PR MPS-2-28-1551

SUSPECT BSTRA ASSEMBLY

Element/End Item: **OV102**

Flow/Usage: **FLIGHT 28/STS107**

The BSTRA is an internal support mechanism for the bellows assemblies of the LO₂ and LH₂ 17 inch and 12 inch feedlines. Each 17 inch feedline has three BSTRA assemblies, each 12 inch feedline has two. Reference figures 10-1 through 10-5 for hardware description.

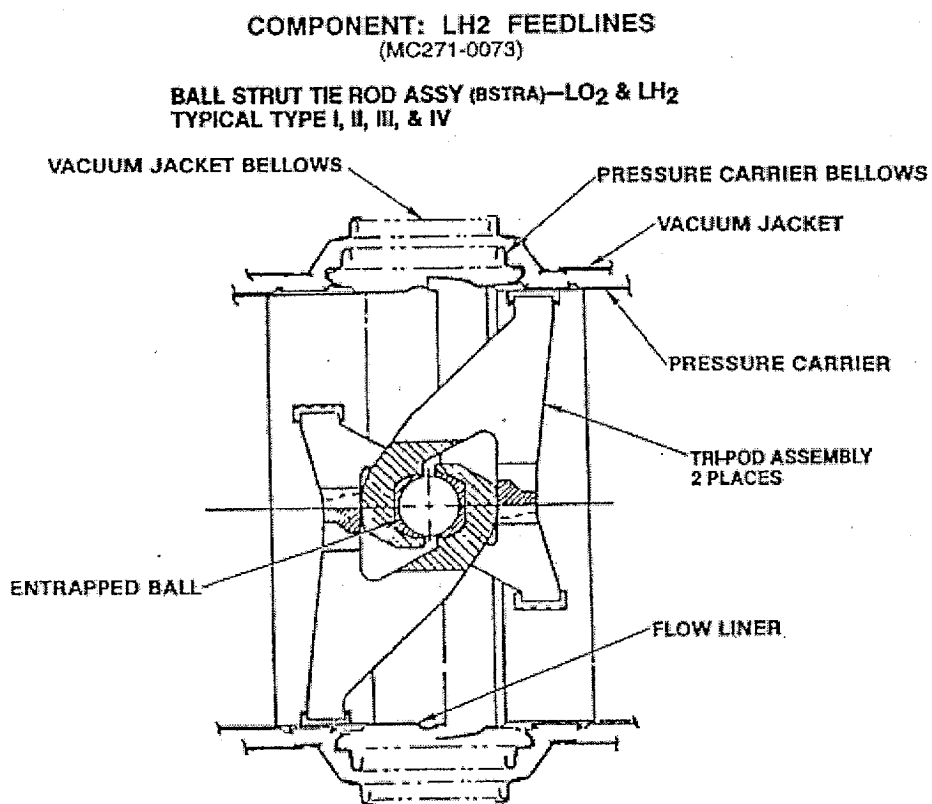
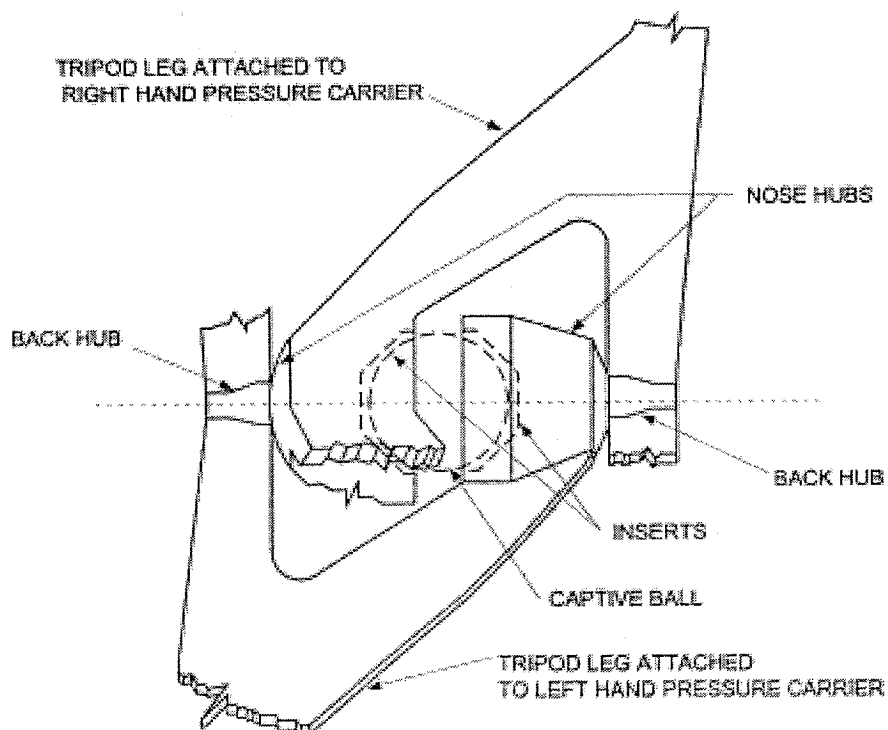
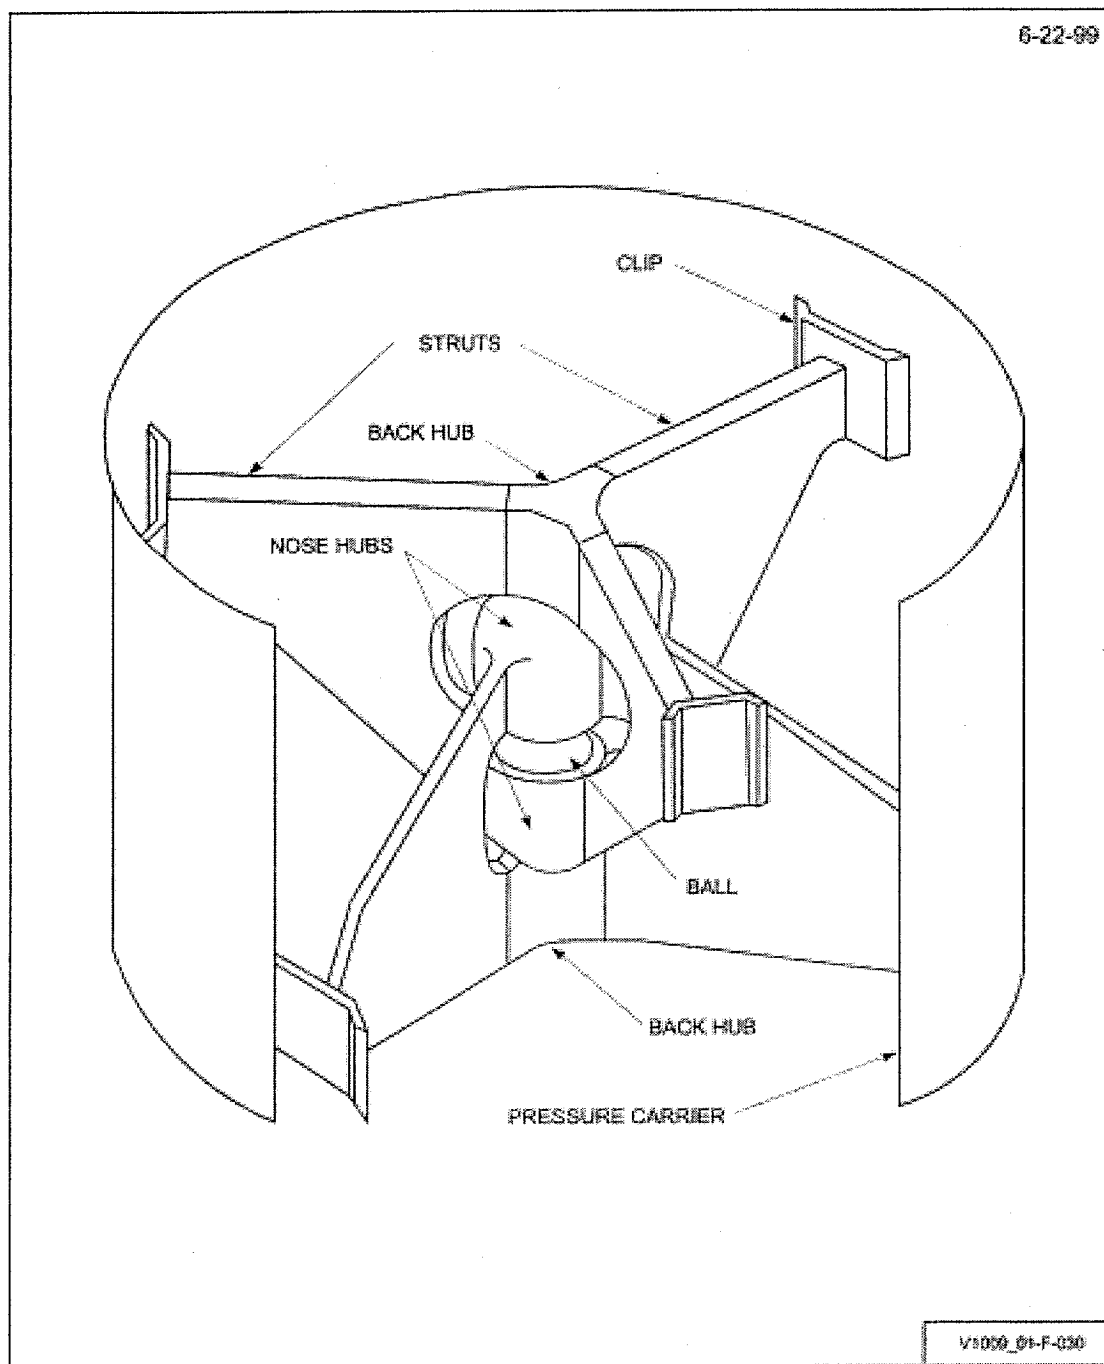
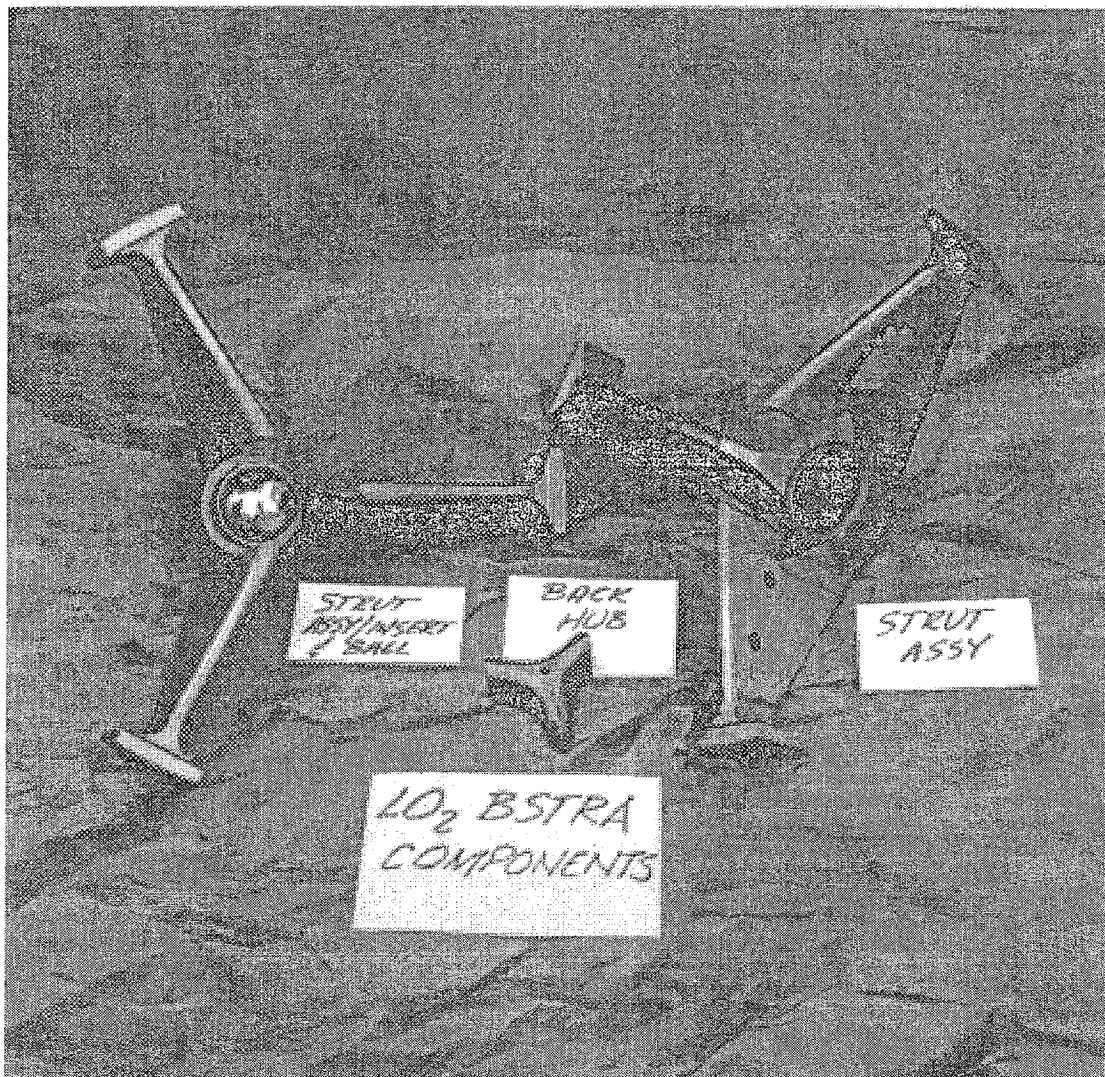
During OV103 OMDP borescope inspections of the Ball-Strut-Tie-Rod-Assemblies (BSTRA), a crack was found in the ball LO₂ 17" feedline aft BSTRA. Consequently, suspect PR's were initiated on all orbiters. Subsequent borescope inspections of all accessible areas of the BSTRA balls in OV103, OV104, and OV105 found no other indications. OV102 could not perform these inspections at the Pad, however, the same video borescope inspections were performed prior to its last flight (STS-109) at Palmdale. No anomalies were noted during the inspection and a review of the videotape reveals no apparent indications.

Upon discovery of the crack, testing to better understand the material properties of the BSTRA balls was accomplished. Tests included subjecting BSTRA balls to cryogenic conditions in conjunction with load forces. The environments that the test specimens were subjected to were extreme when compared to the flight environment the balls typically are exposed to (i.e.: bare balls thermally shocked at cryogenic temperatures, dynamic portion of each loading cycle represents approximately 4X actual environment, higher thermal gradients). The following conclusions have been drawn from recent testing: cracks arrest, BSTRA ball cracks do not limit functionality, many features (islands, branching, fines, and FOD) were observed, and no FOD greater than 400 micron equivalent size has been produced.

M&P Team has observed metallurgical characteristics in the test specimens and concluded that the indication of the jagged nature of the fracture provides a locking feature to preclude large island liberation. The size of the particulate generated has been evaluated by Rocketdyne and is within operational experience and design limits of the SSME. Particulate of the type and amount seen during testing could readily be ingested by the engine and is not a concern.

The model developed by the Stress Team agrees with test, analysis, and observations and substantiates the conservatism of testing.

Based on Boeing design, USA, Boeing and NASA test and analysis, and the absence of indications from the review of the most recent OMDP borescope inspection, OV102 has been approved for one flight by the Space Shuttle Program Manager. This PR will be deferred to flight 29 of OV102 when further inspections will take place.

Post flight disposition will include a thorough inspection of the BSTRA balls using video borescope. If access permits, a ball manipulation tool in conjunction with the GSE struts to rotate the balls within the BSTRA's will be used.
